## EXHIBIT A - GMP SUMMARY

PROJECT NO.: 6702491  
 PROJECT NAME: Tempe Public Library Renovation  
 DATE: May 4, 2009

01 Issued For Bidding Drawing Clarifications

**22 05 00:**

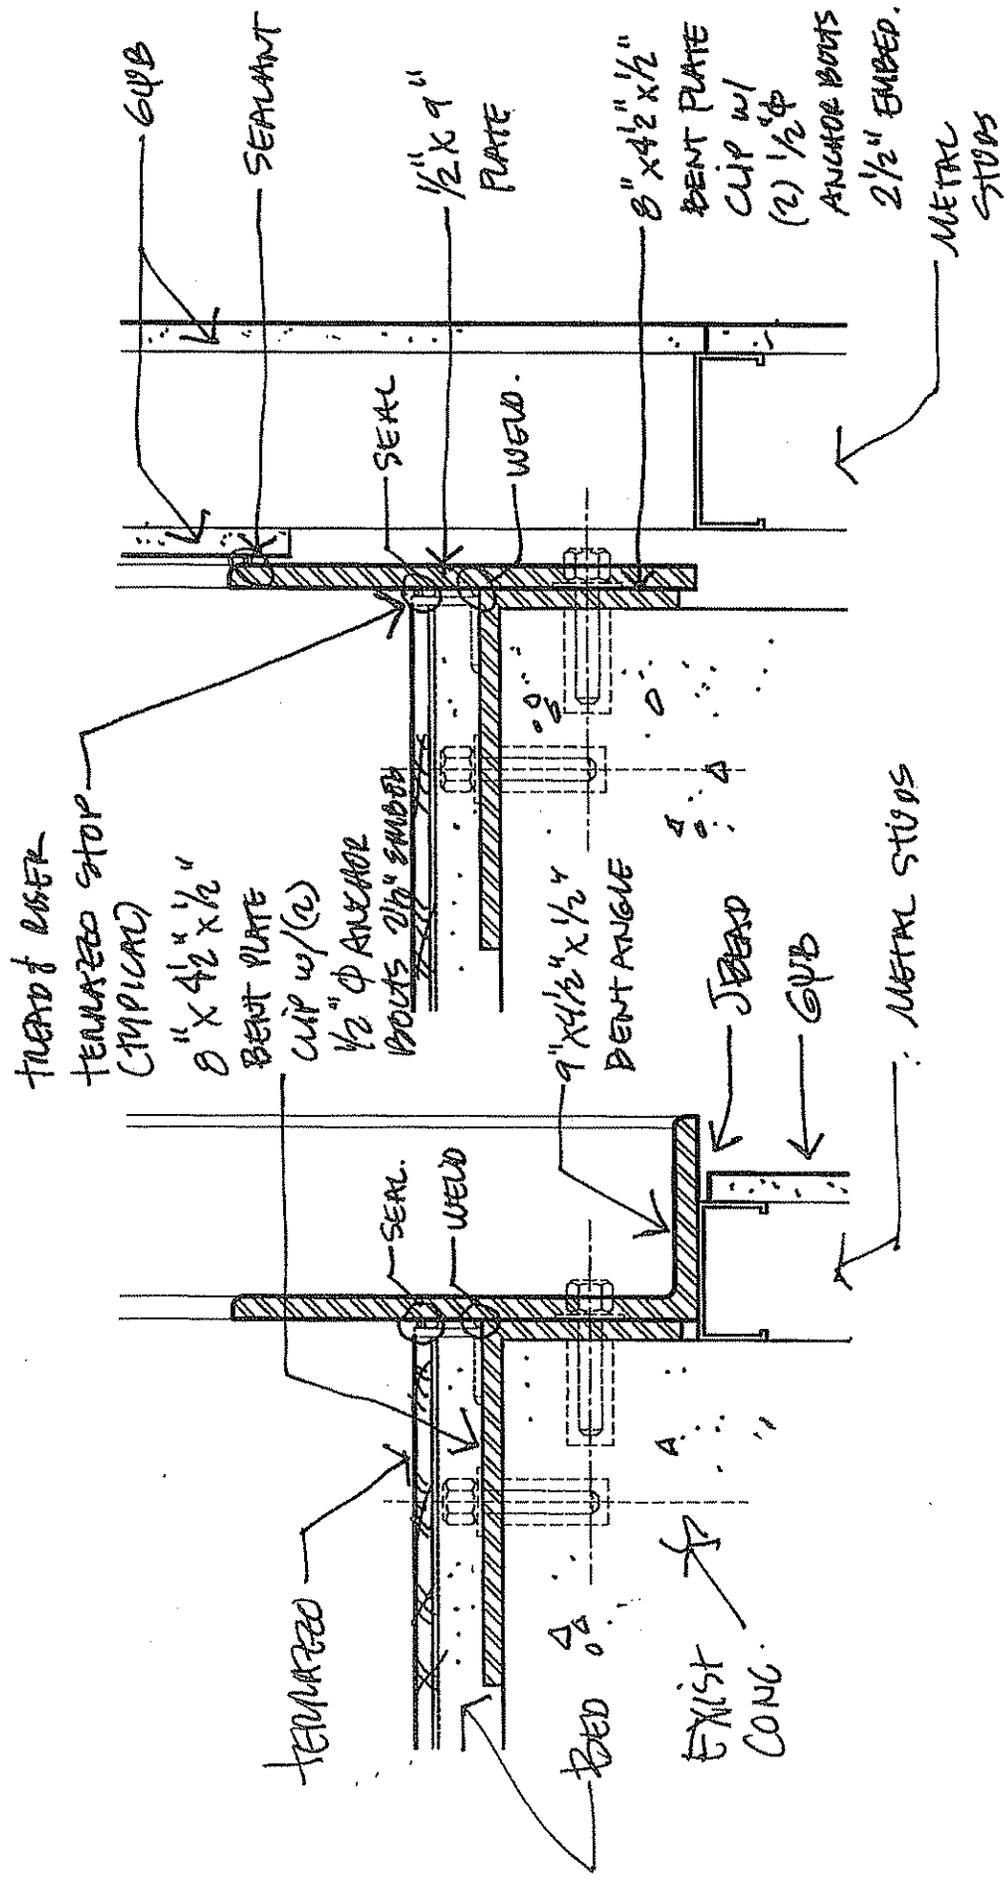
1. For Bathrooms 1024, 1023, 2016, & 2015, existing plumbing fixtures & partitions are shown to be left in-place. For us to re-tile the bathroom & replace the drywall walls although going to be re-used we need a note that the fixtures are to be removed & stored on-site while renovations then fixtures are to be re-installed in same locations. See P201 & P202 for locations but not as specific with fixtures as other locations of the drawings. **EADP RESPONSE: DEMO NOTE #34 ON SHEETS D101A & D102A REFERS TO REMOVING PARTITIONS, TOILETS, AND URINALS TO BE STORED AND REINSTALLED. SINKS, COUNTERS TO BE REMOVED AND REPLACED WITH NEW PER PLUMBING PLAN P201, P202 SEE NOTE '1' ON DETAILS 2/P201 AND 2/P202.**

SECTION DETAIL  
 TREAD CLIPS  
 SCALE 3" = 1'-0"

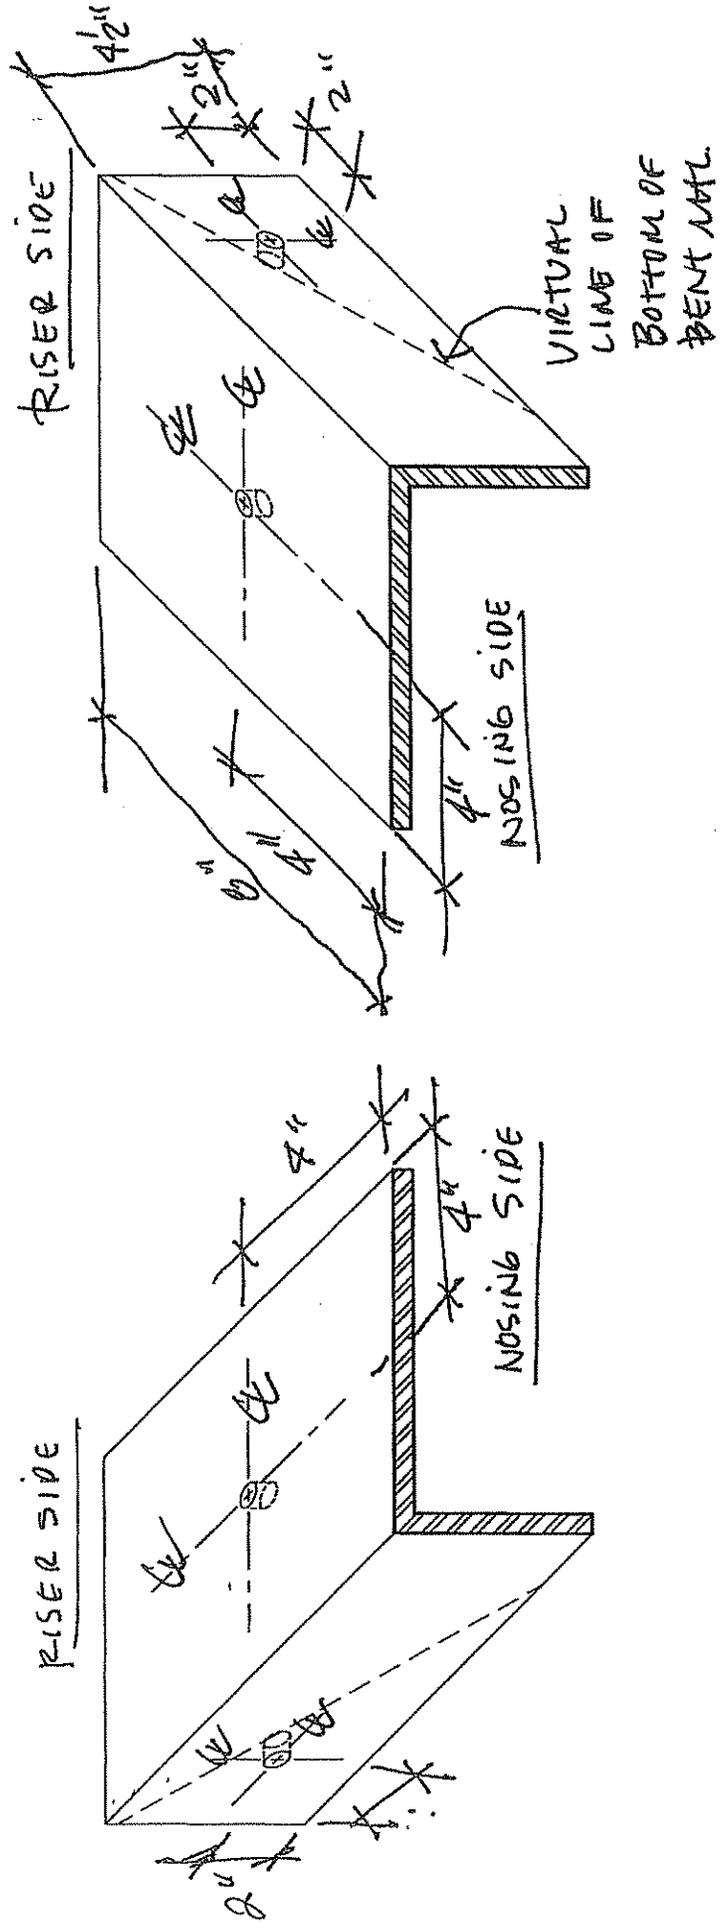
SEAL.  
 WELD.  
 9" X 4 1/2" X 1/2"  
 BENT ANGLE  
 JERAD  
 GVB

SEALANT  
 1/2" X 9"  
 PLATE  
 8" X 4 1/2" X 1/2"  
 BENT PLATE  
 CLIP w/  
 (2) 1/2" Φ  
 ANCHOR BOLTS  
 2 1/2" EMBED.
